Second Revision No. 15-NFPA 13D-2017 [Chapter 2]

Second Revision No. 1-NFPA 13D-2017 [Section No. 7.4.5]

Figure 8.2.1.2(a) Position of Sprinkler Under a Beam.

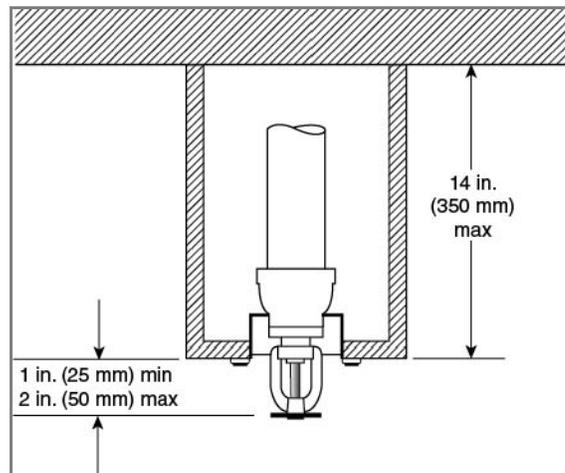
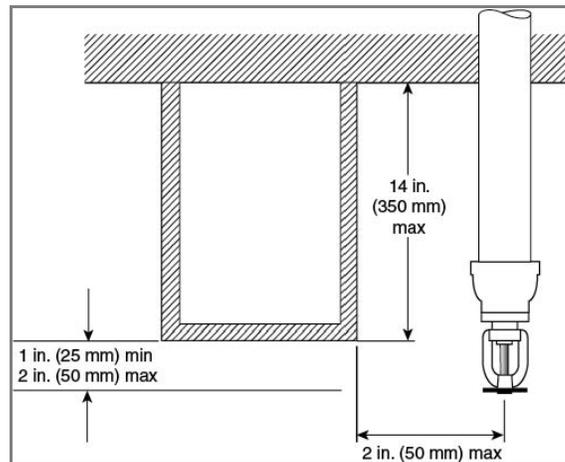
Pendent-type residential sprinklers located under or adjacent to beams in accordance with 10.2.1 shall be installed in accordance with one of the following:

- (1) Pendent, recessed pendent, and flush-type pendent sprinklers shall be permitted to be installed directly under a beam having a maximum depth of 14 in. (350 mm) with the sprinkler deflector 1 in. to 2 in. (25 mm to 50 mm) below the beam, or in accordance with the manufacturer's instructions for recessed or flush sprinklers if the deflector is less than 1 in. (25 mm) below the beam, as shown in Figure 8.2.1.2(a).
- (2) Pendent sprinklers, ~~including flush-type pendent sprinklers,~~ shall be permitted to be installed adjacent to beams where the vertical centerline of the sprinkler is no greater than 2 in. (50 mm) from the edge of the beam and with the sprinkler deflector 1 in. to 2 in. (25 mm to 50 mm) below the beam, or in accordance with the manufacturer's instructions for flush sprinklers if the deflector is less than 1 in. (25 mm) below the beam, as shown in Figure 8.2.1.2(b).

Committee Statement: This comment is in support of FR 32 and seeks to add two figures to illustrate the requirements for installing sprinklers under and adjacent to beams,

Note this section and new figures have also been submitted to NFPA 13 and the figures submitted to NFPA 13R. See attached figures, Figure 8.2.1.2(1) and Figure 8.2.1.2(2).

Figure A.6.2(e) Acceptable Arrangement for Townhouse Stand-Alone Piping Systems.

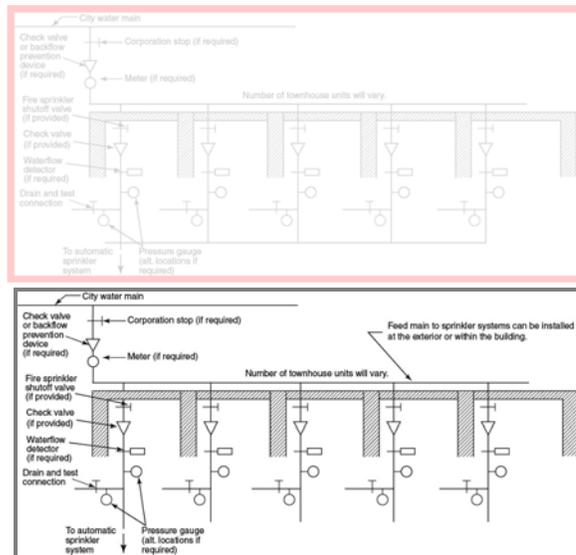
Committee Statement: Figure has been modified to remove the connection line shown on the inside and a note has been added to clarify that the supply can be either inside or outside of the structure. See revised attached Figure. The text has been modified to take into account concerns raised by the water utility industry.

Figure A.7.5.6.3(3)(a) Recessed Fireplace — Ordinary Temperature Sprinkler Location .

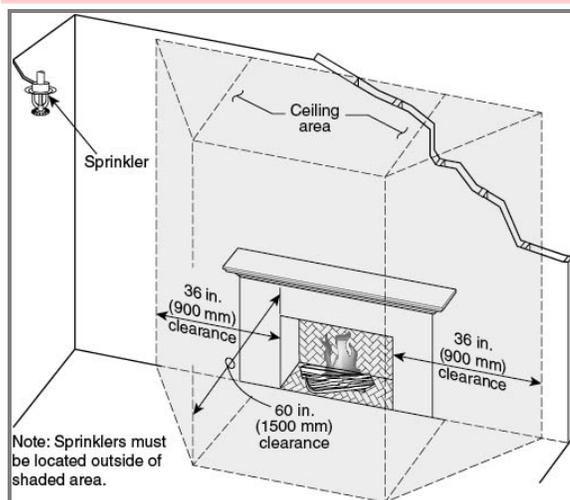
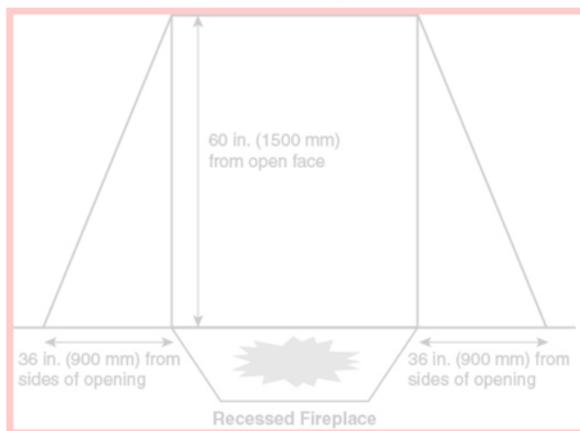
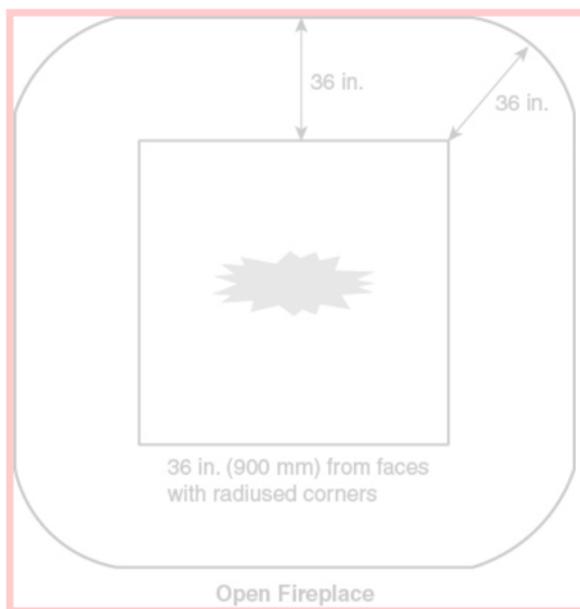
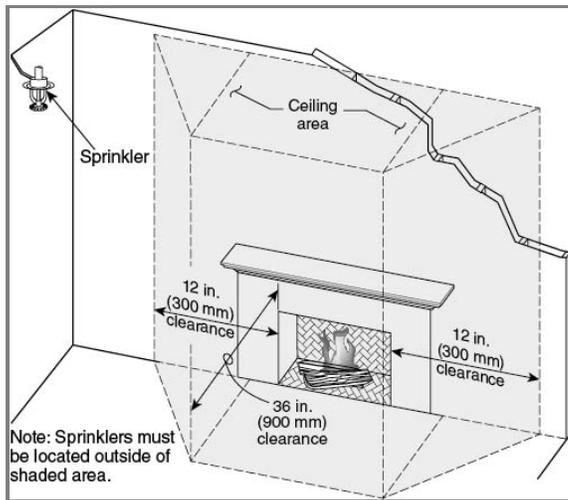
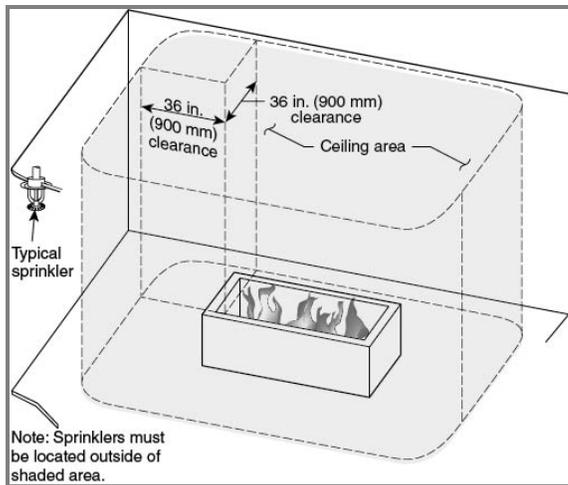
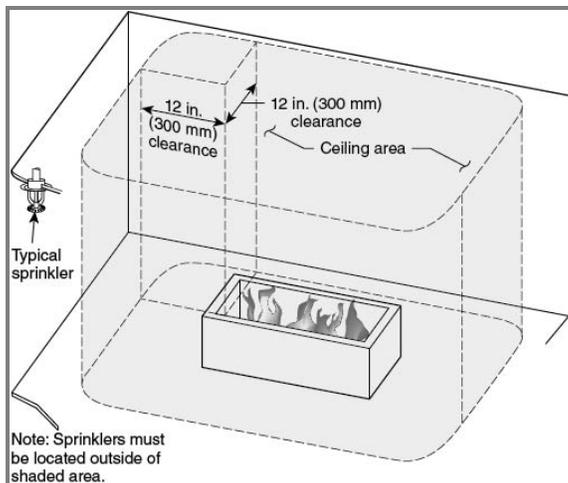
See Figure A.7.5.6.3(3)(a), and Figure A.7.5.6.3(3)(b), Figure A.7.5.6.3(3)(c), and Figure A.7.5.6.3(3)(d).

Committee Statement: Improved drawings have been submitted to illustrate the concept accepted in the First Revision. This should be correlated across NFPA 13 and NFPA 13R. See attached figures.

Figure A.10.2(a) Sprinkler Design Areas for Typical Residential Occupancy — Without Lintel With Lintel Between Adjoining Spaces: Dining Room and Hall .

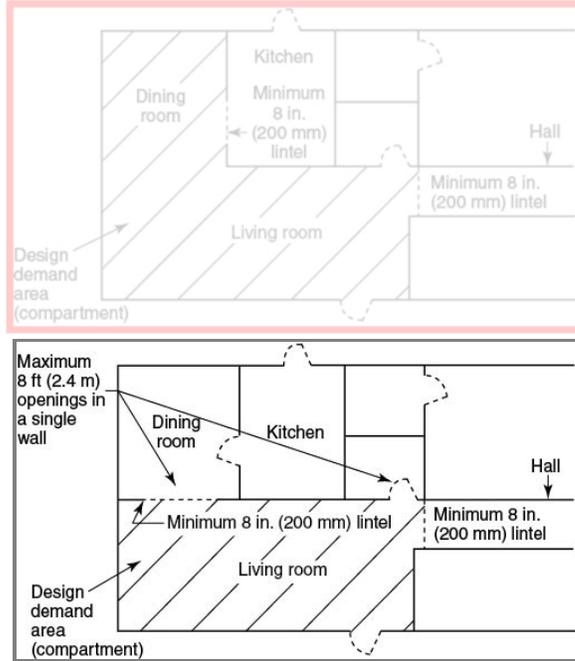
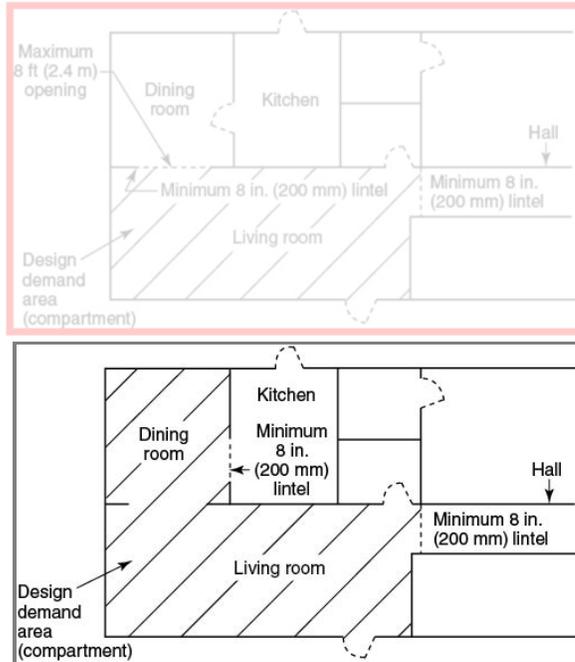
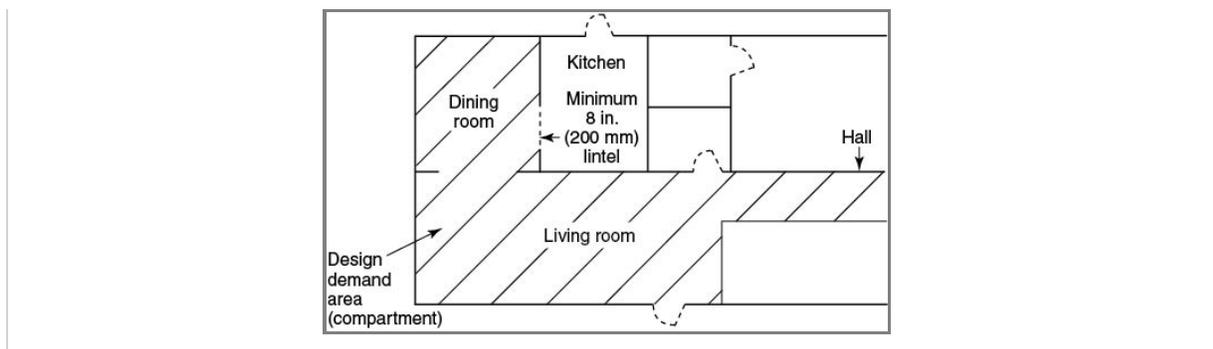
For examples of selecting a compartment for consideration, see [Figure A.10.2\(a\)](#), [and Figure A.10.2\(b\)](#), [and Figure A.10.2\(c\)](#), which show examples of design configurations for compartments based on the presence of lintels to stop the flow of heat. In all three figures, the area under consideration for determining the number of design sprinklers is the living room. In Figure A.10.2(a), the living room is considered a compartment since the opening to the hall has an 8 in. (200 mm) lintel, the opening to the dining room has an 8 in. (200 mm) lintel, and all openings on that wall are limited to 8 ft (2.4 m). In Figure A.10.2(b), the living room and dining room are considered one compartment due to the lack of a lintel between the two spaces. The hall is a separate compartment since there is still an 8 in. (200 mm) lintel between the living room and hall. In Figure A.10.2(c), the living room, dining room, and hall are considered one compartment since there are no lintels separating those spaces.

Committee Statement: The annex text has been modified to clarify the application of the rules regarding the definition of compartment. The existing figures have been modified and a new figure has been added. See attached figures.
